## ADDENDUM NO. 3

To: All Plan Holders of Record and Interested Parties  
Project: Clinton County Administration Building - Addition & Alterations  
Project No.: 22072  
Issue Date: March 5<sup>th</sup>, 2024  
Bids Due: 2:00 PM, March 13, 2024

M202

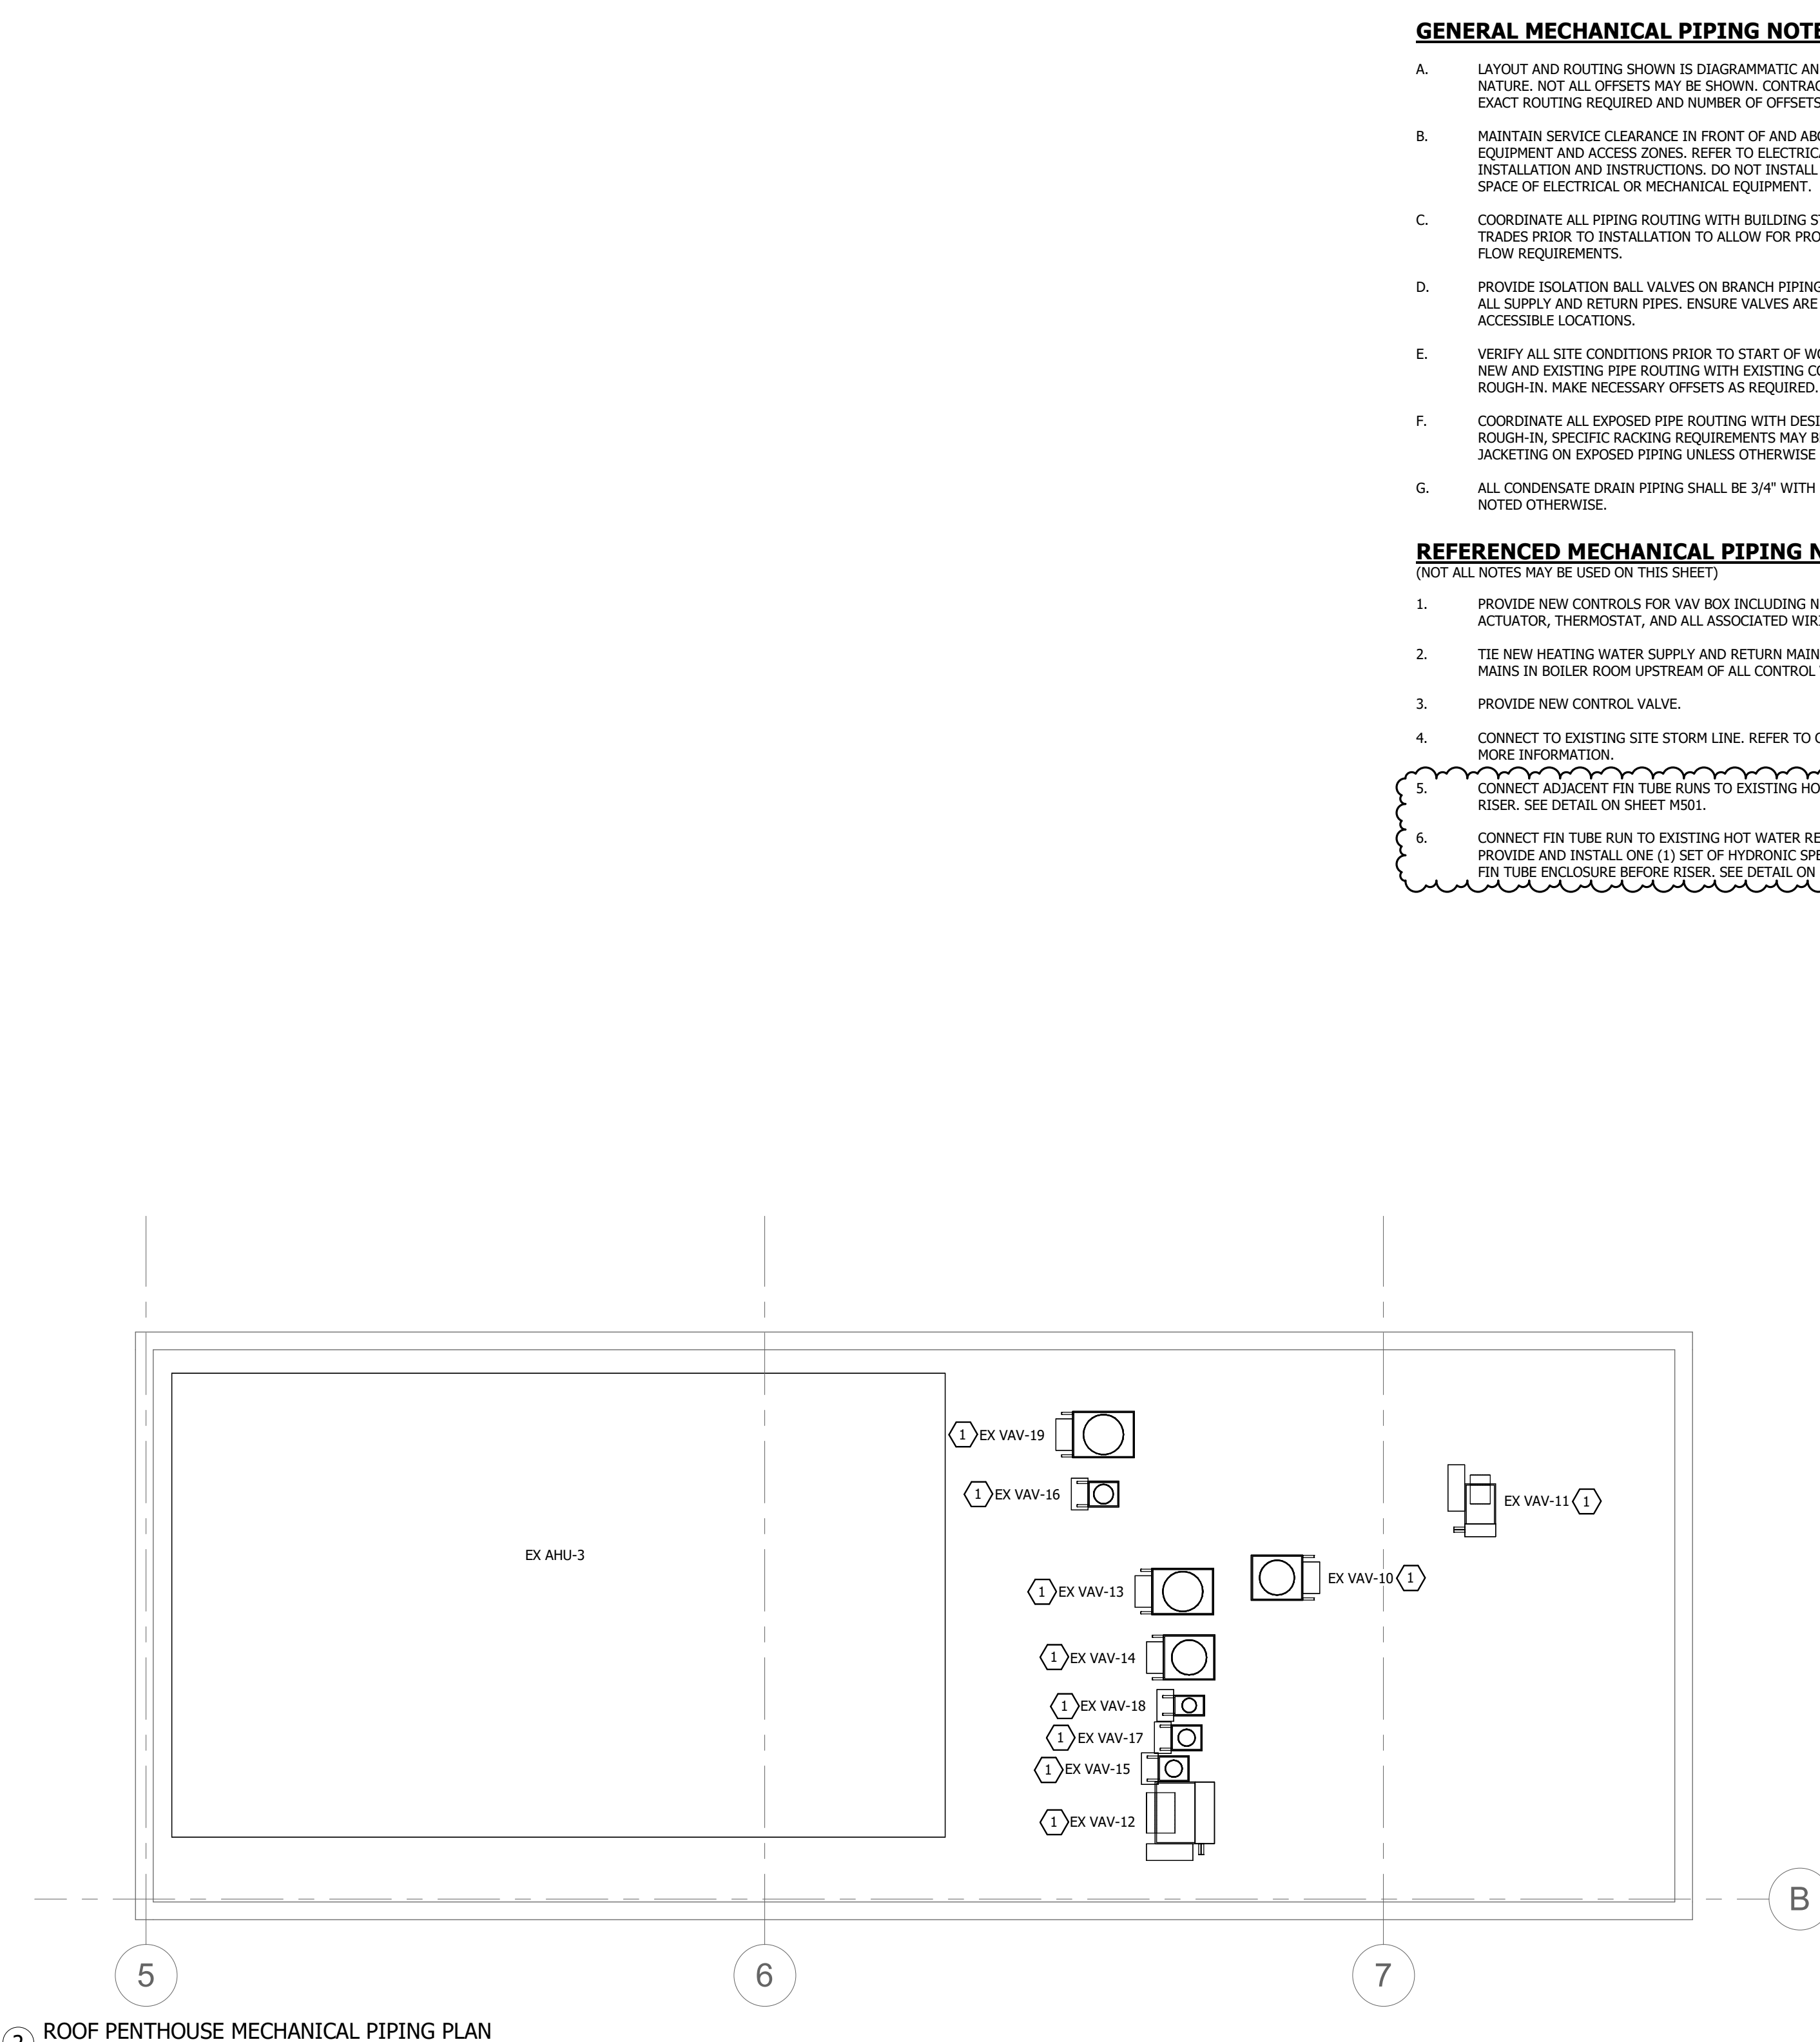
- 1. Referenced Mechanical Notes
  - A. **ADD** Note 5 to read: "Connect adjacent fin tube runs to existing hot water supply riser. See detail on sheet M501."
  - B. **ADD** Note 6 to read: "CONNECT FIN TUBE RUN TO EXISTING HOT WATER RETURN RISER. PROVIDE AND INSTALL ONE (1) SET OF HYDRONIC SPECIALTIES IN LAST FIN TUBE ENCLOSURE BEFORE RISER. SEE DETAIL ON SHEET M501."
- 2. Second Floor Mechanical Plan
  - A. **ADD** Note 5 to hot water supply riser locations. See reissued sheet for more details.
  - B. **ADD** Note 6 to end of fin tube runs where they connect to the return risers. See reissued sheet for more details.
